Townsville Ocean Terminal & Breakwater Cove

5002/02
R-KO0131 –Rev 3
30 July 2008

Water Quality Management during Construction

SITE PLAN
FIGURE 1

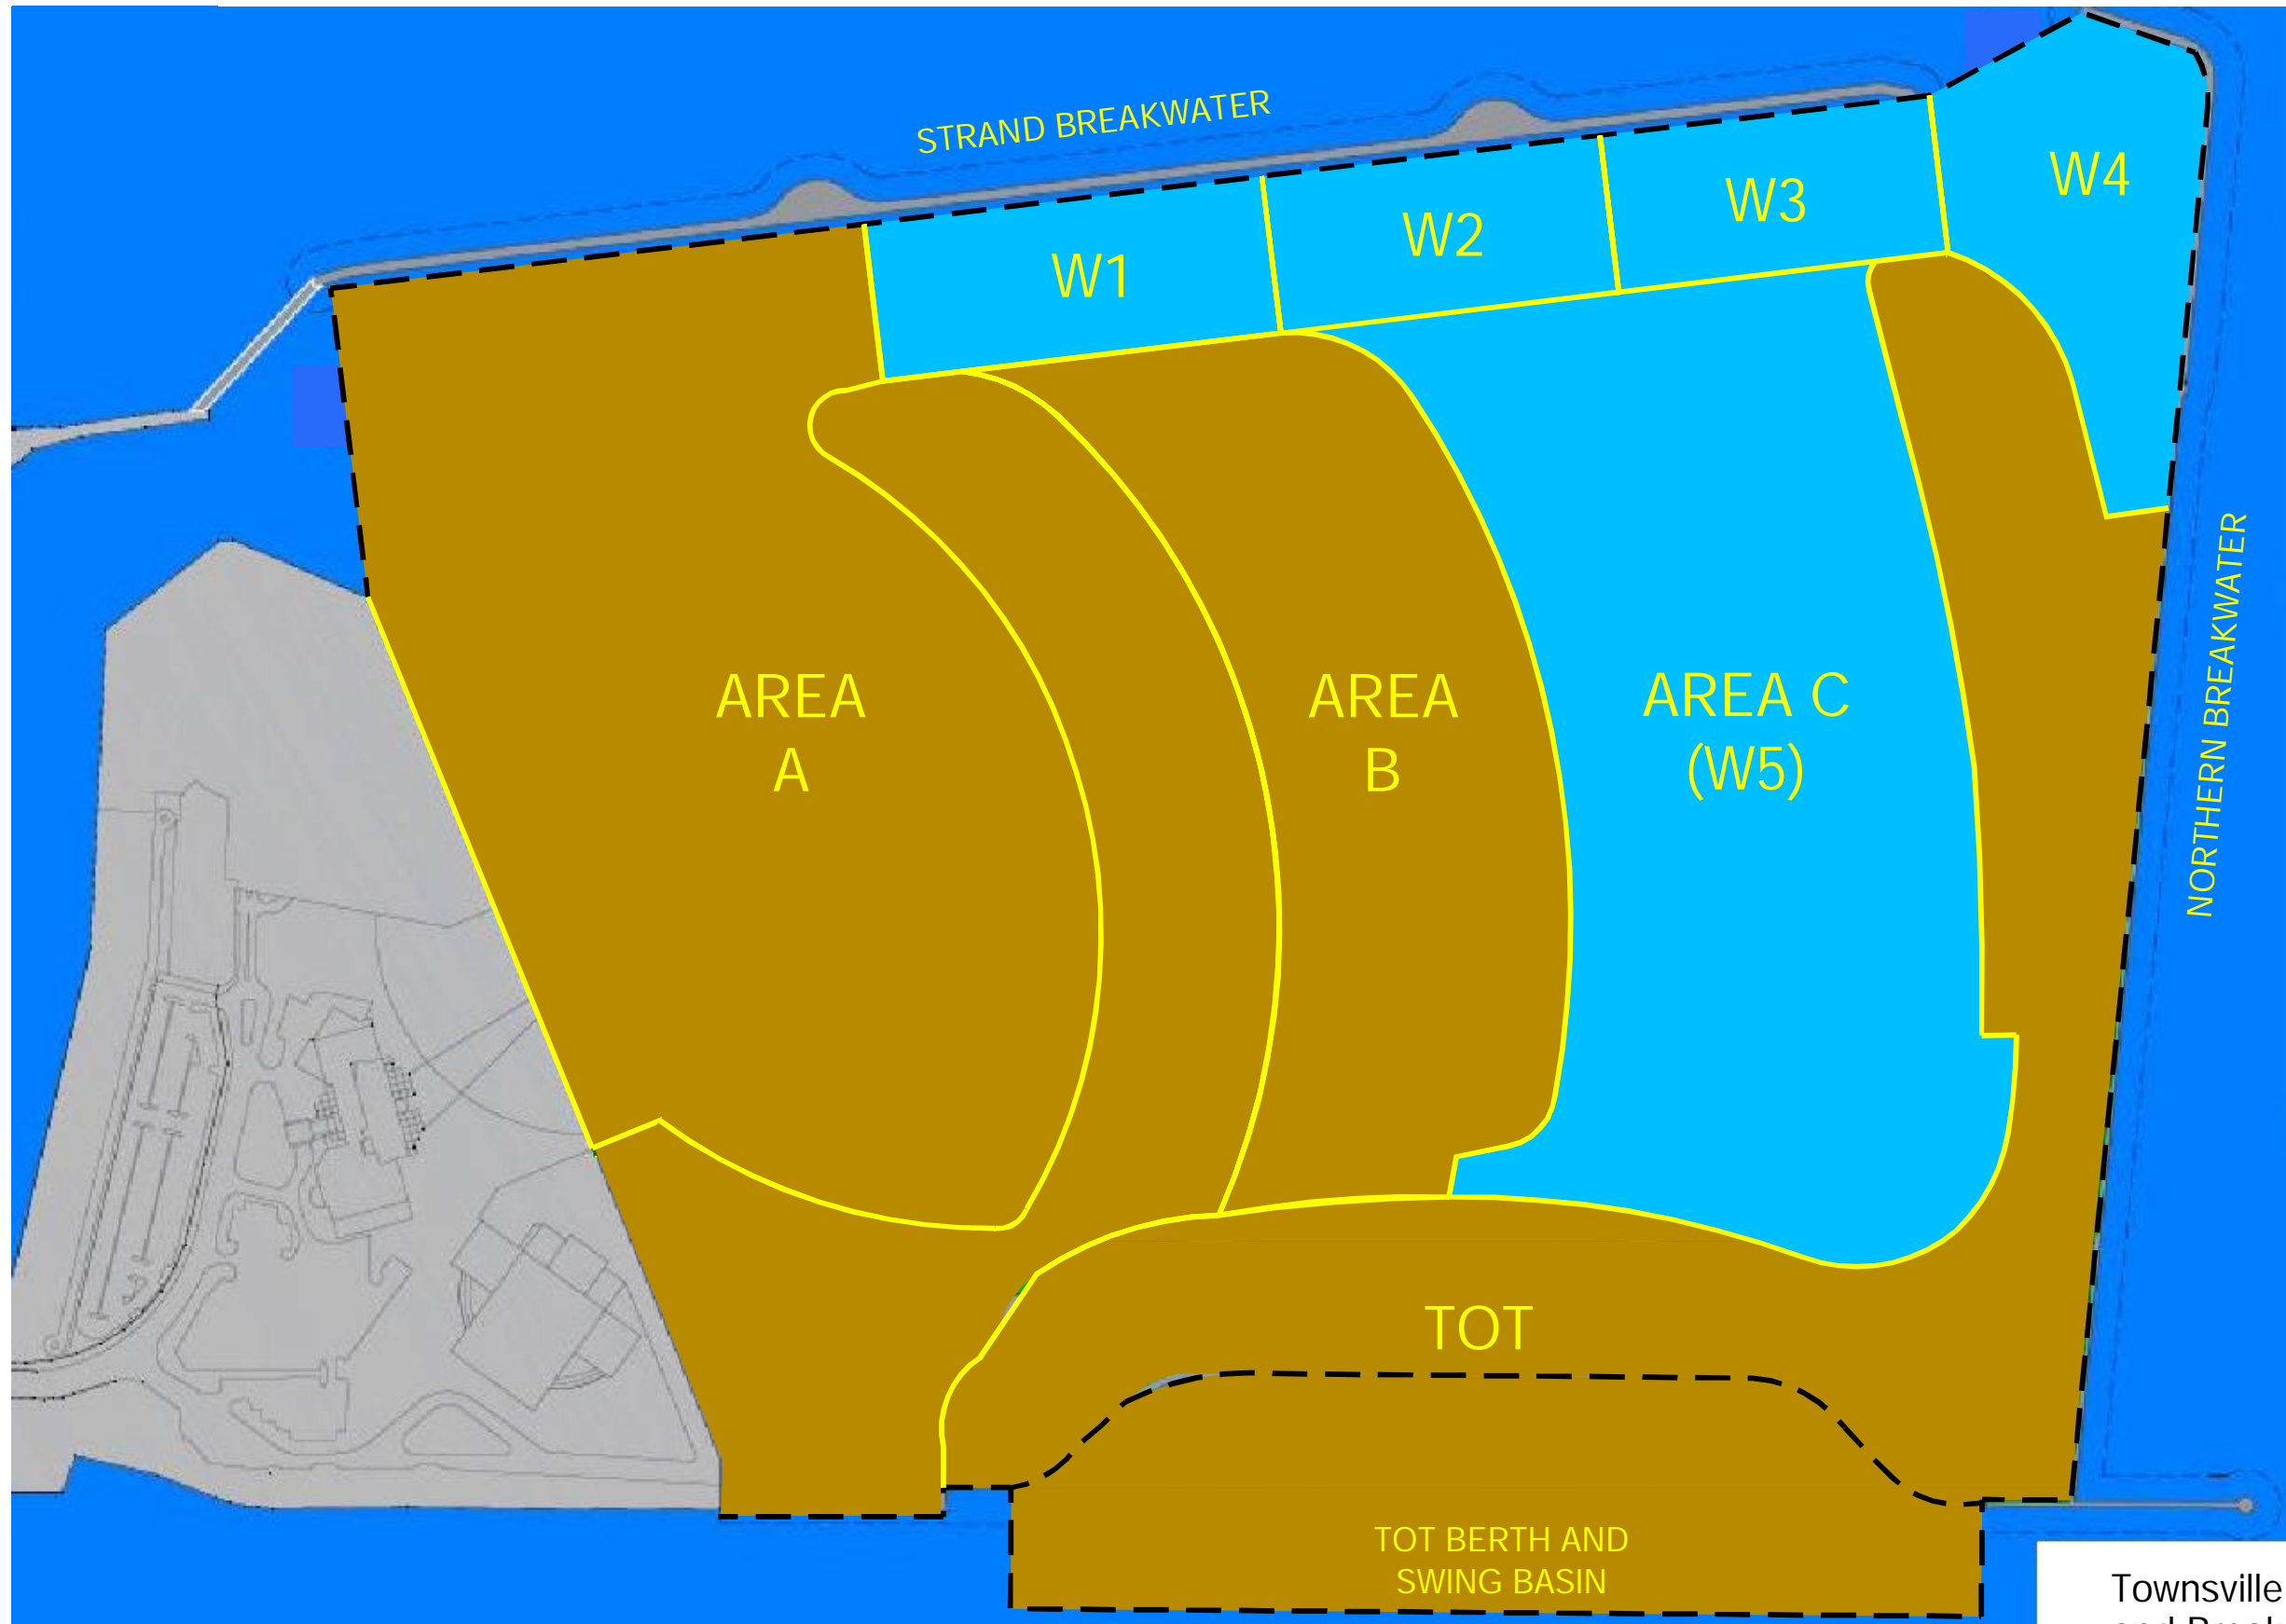
The revised construction plan has taken into account the need for storage areas and water collection and control within the enclosed site.

The site plan (**Figure 1**) shows the layout of the storage areas (Area A, B & C) and water ponds (W1-W5)

The capacity of each pond and area has been calculated as shown in **Appendix A Calculation of Water Volumes and Storage Capacity**. Each of these areas may be further subdivided as identified in operational works and as required during construction works. The layout of the ponds allows for at least two ponds for each stage of construction and the development of a treatment train, if required. The sizing of the ponds allows for capture and containment of a 50 year ARI event, should it occur.
